ARCHITECT'S PROJECT #1708 4J SCHOOL DISTRICT CIP# 600.766.000
4J SCHOOL DISTRICT
NORTH EUGENE HIGH SCHOOL
TRACK SHED 2018
200 SILVER LANE
EUGENE, OREGON 97404

This addendum, consisting of a total of (3) pages, forms a part of the Contract Documents and modifies the original Drawings dated February 5, 2018. Acknowledge receipt of this Addendum in the space provided on the Bid Form. Failure to do so may subject the Bidder to disqualification.

SHEET NUMBER
A2

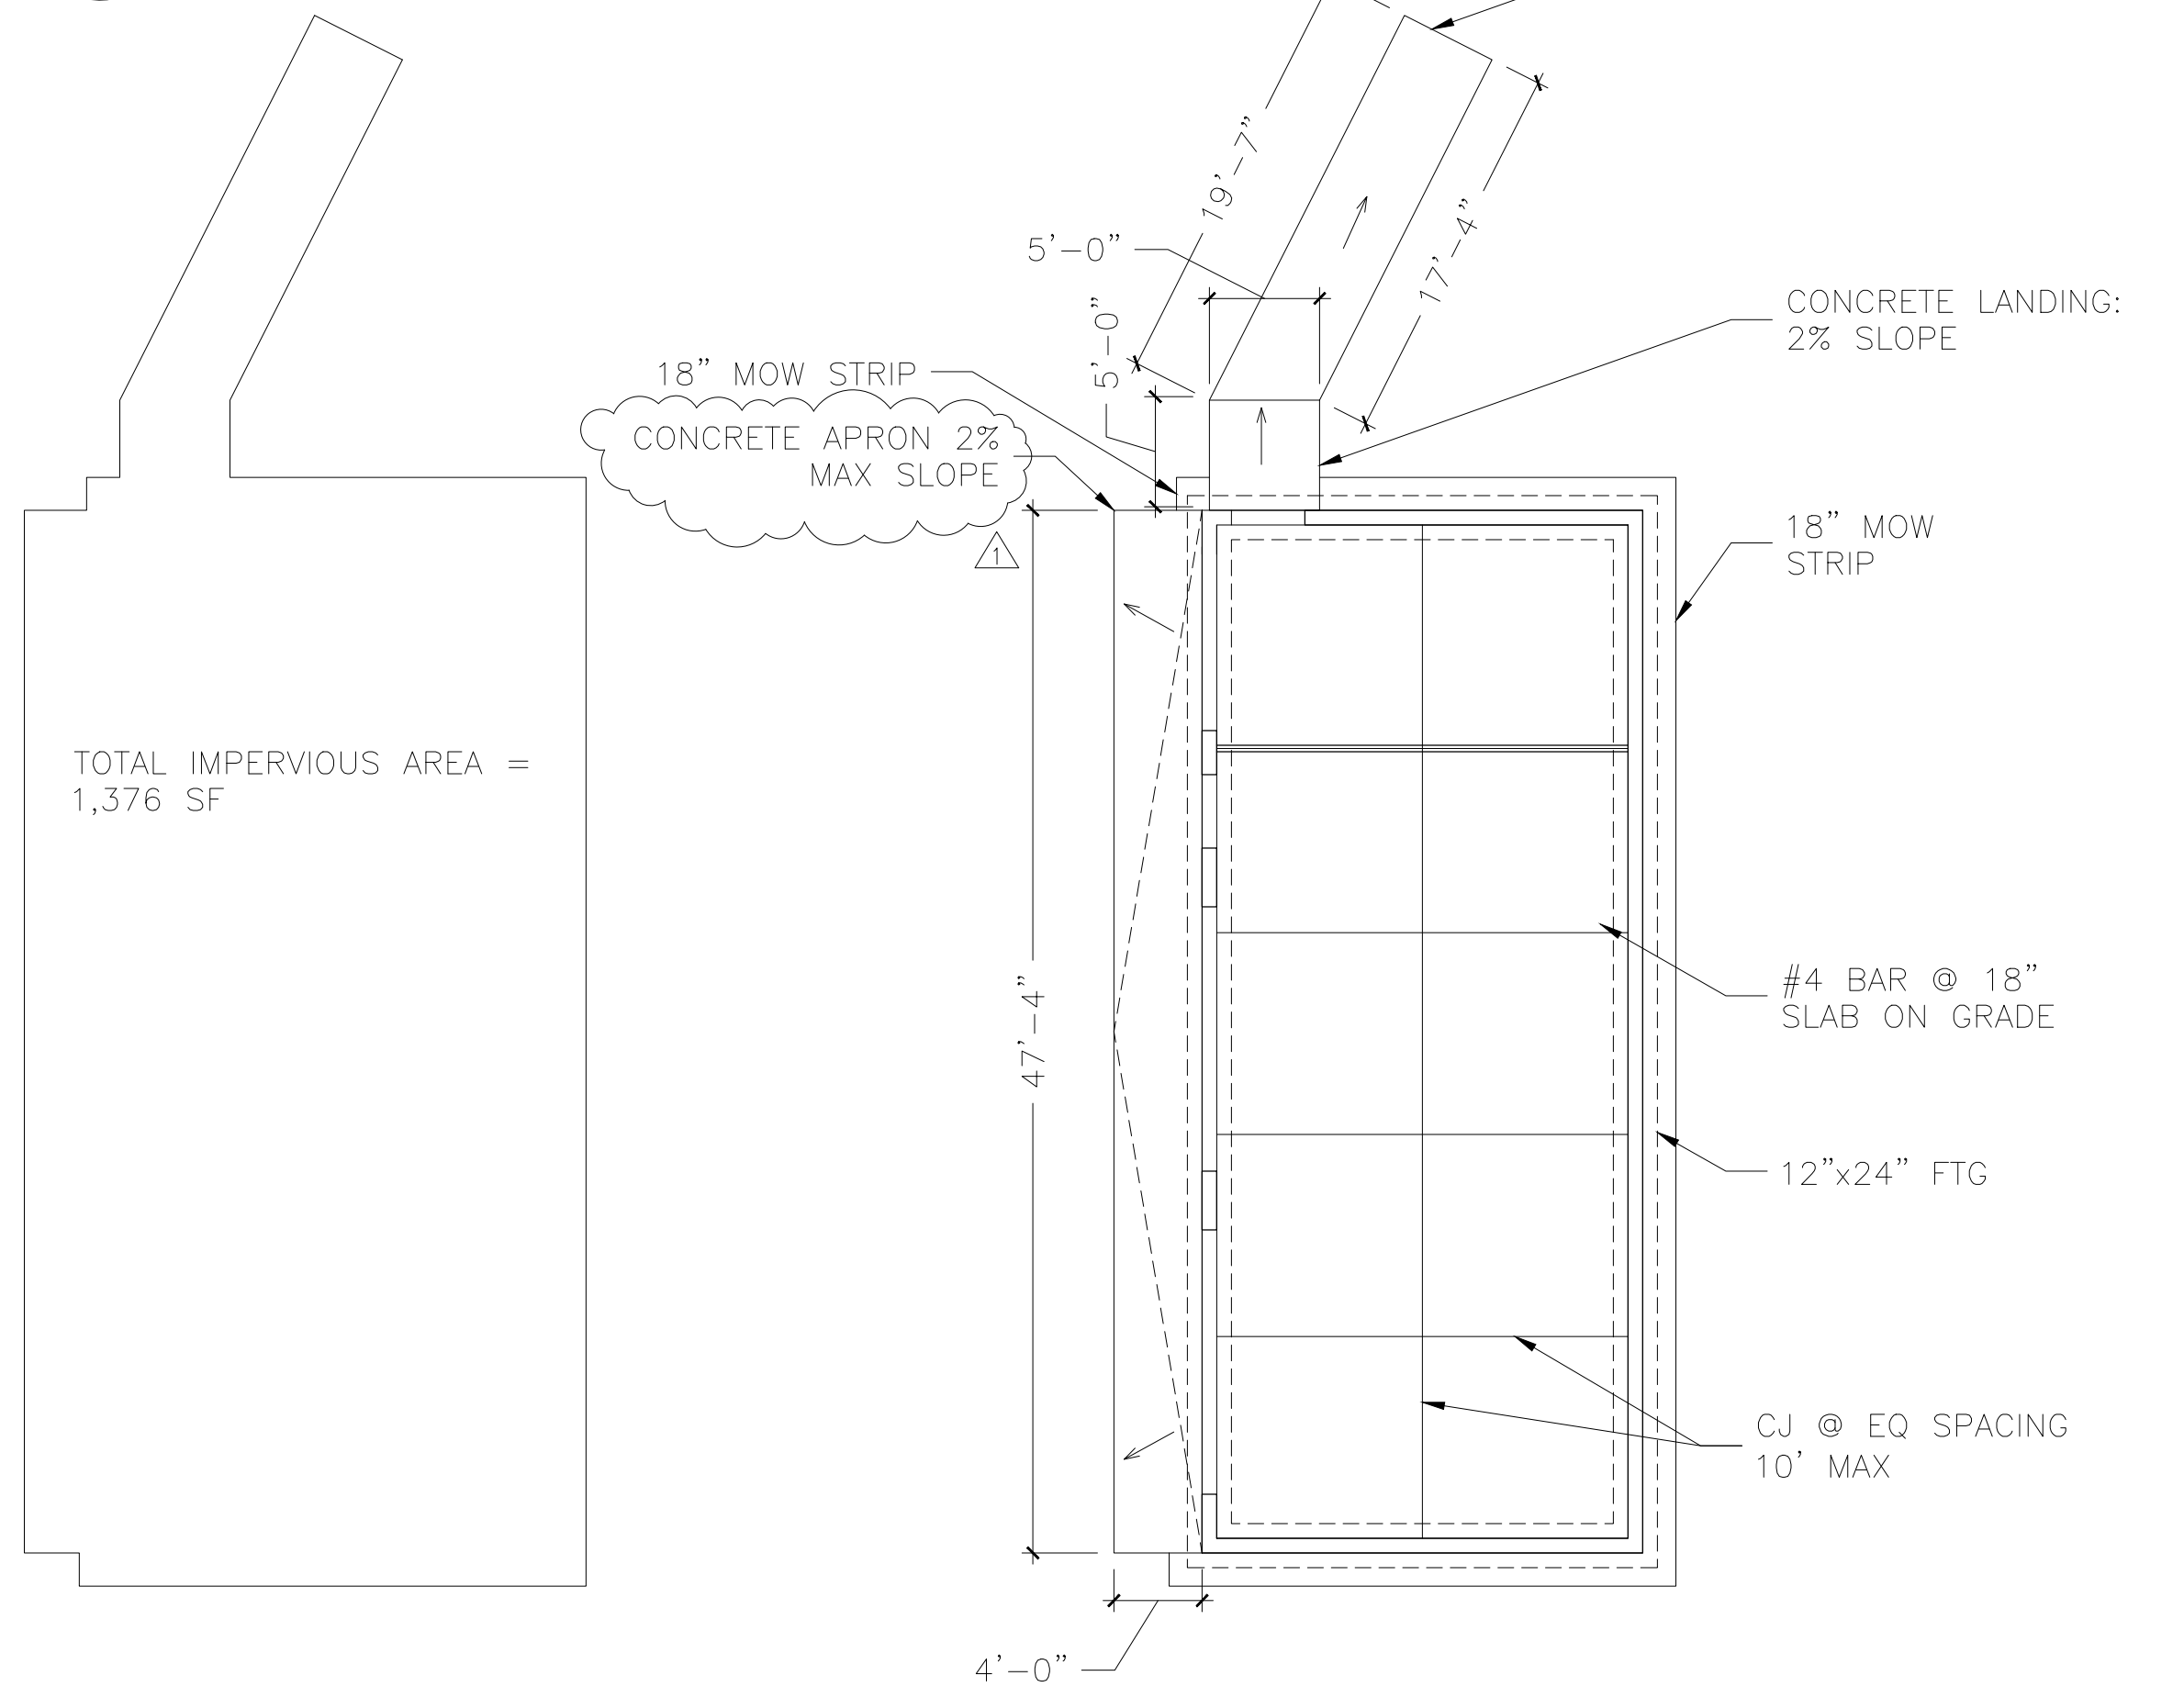
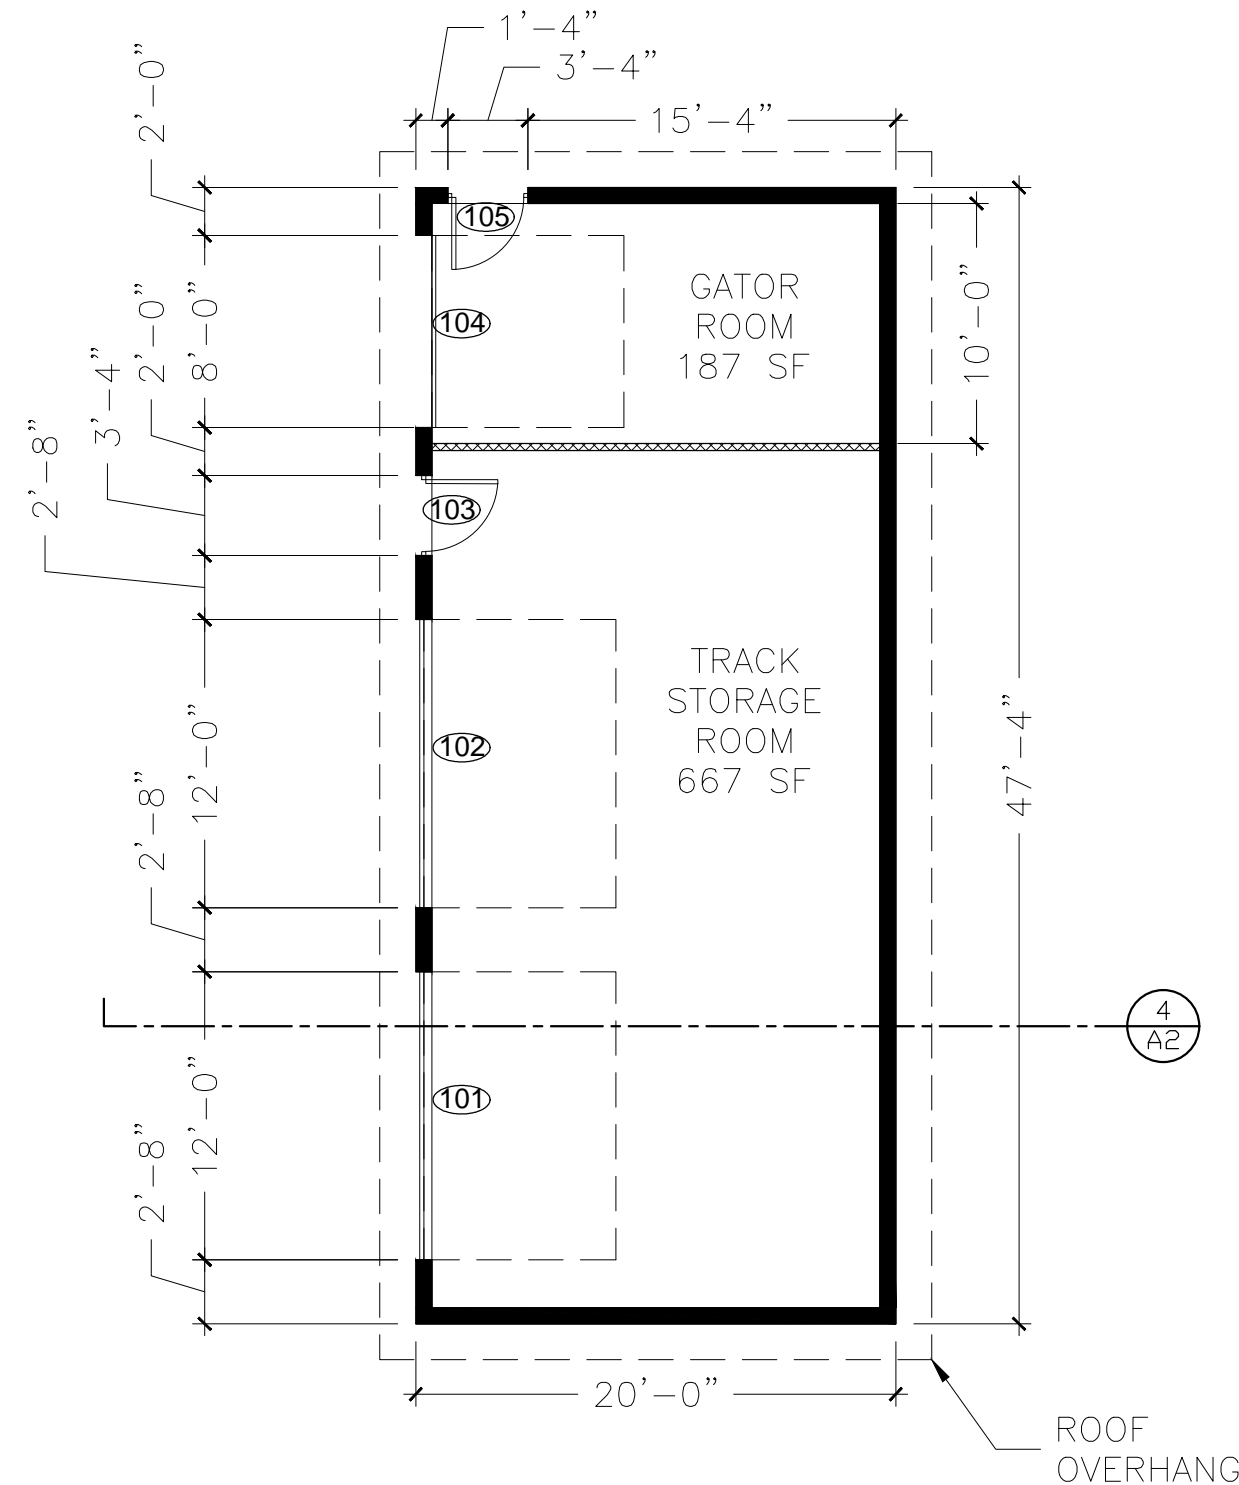
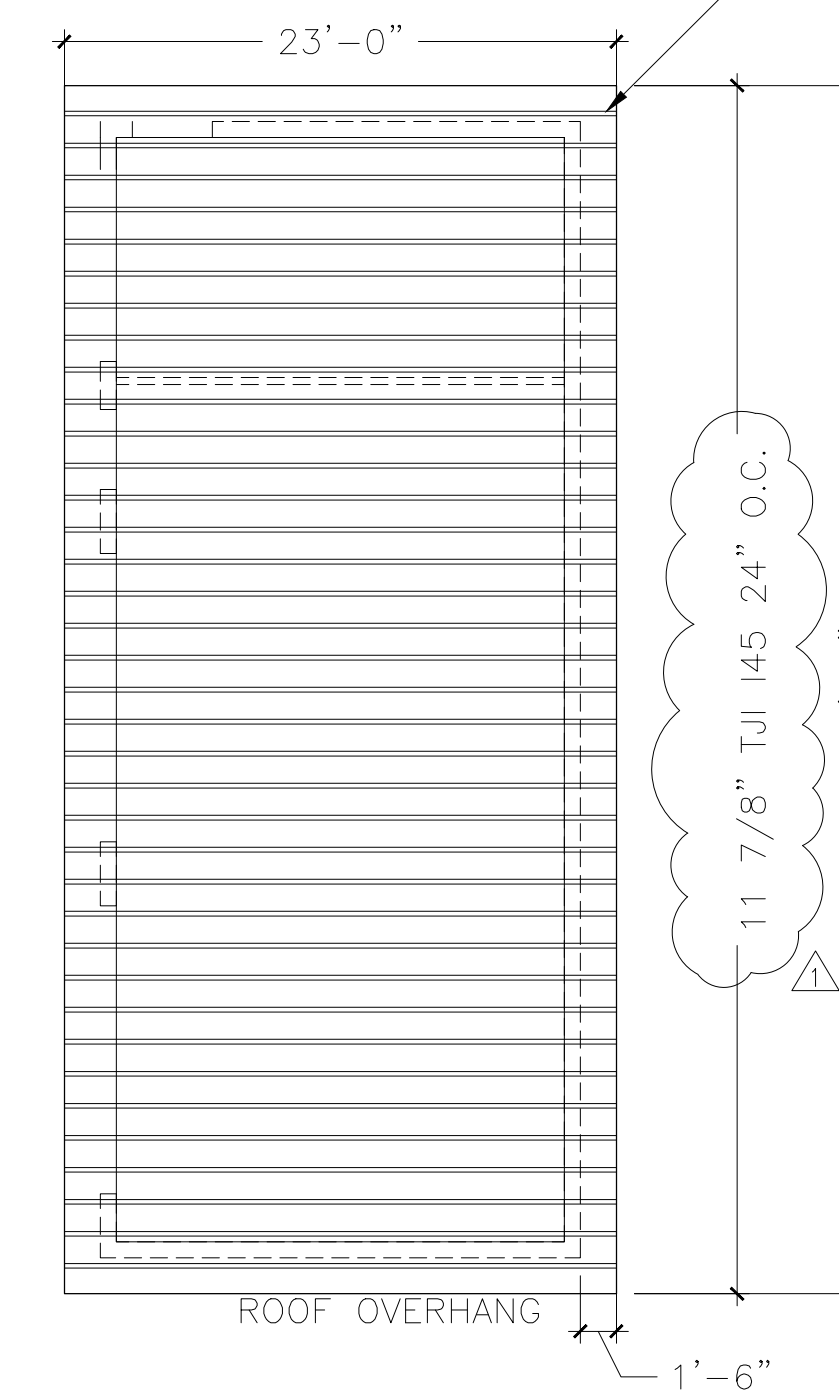
3. A2 Rev#1- Correction of joist type.
4. A2 Rev#1- Correction of 2% maximum apron slope.
5. A2 Rev#1- Set grade: slope up 1/2" per foot from existing grade. Clarification: Toe of apron establishes datum for elevation of building slab.

6. A2 Rev#1- Warp apron to drain.
7. A2 Rev#1- Saw cut existing asphalt for excavation and construction.
8. A2 Rev#1- Substitute 430 OH Doors for 416 OH Doors. See Specifications #2 below.

Q1: *Roof framing on A2 calls for the joist's to be 11 7/8" TJI 360 at 16" o/c but on detail 5/A4 it calls out for 11 7/8" Red – 145 at 24" o/c which one is correct?*

A1: 11 7/8" TJI I45 at 24" O.C. is correct. The attached drawing A2 Rev#1 has been corrected.
